Re: Amended GW-11 Volume Calculations
Nevada Environmental Response Trust Site; Henderson, NV
Dam Permit #J-665

Attachment: GW-11 Pond Stage/Area/Capacity Table and Curve

GW-11 Pond Volume Model Version 1.1

GW-11 Pond, Permit J-665 Nevada Environmental Response Trust

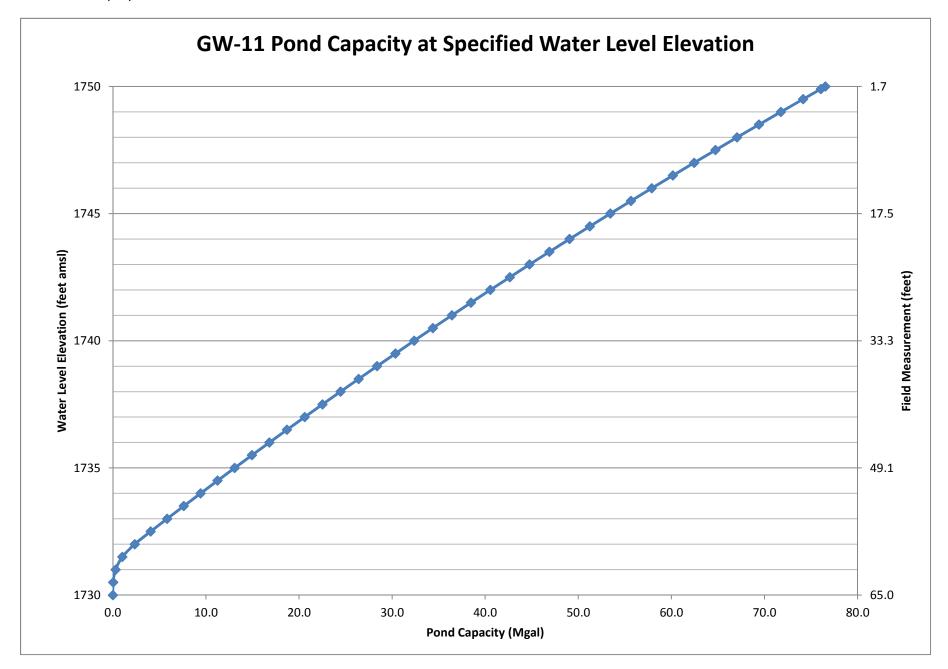
ENVIRON recently reviewed the volume calculations for GW-11 to verify its capacity and found that an elevation of 1747 feet above msl does not correspond to a capacity of 114 acre-feet, as stated in the Dam Permit. ENVIRON's revised volume calculations indicate that an elevation of 1747 feet above msl actually corresponds to a capacity of approximately 192 acre-feet. Attached to this letter is a stage/area/capacity table and curve, which reflect the revised GW-11 volumes based on ENVIRON's recent calculations. ENVIRON, on behalf of the Trust, hereby requests a minor modification to Attachment A, Item 6 of the Dam Permit to reflect the revised GW-11 volume calculations.
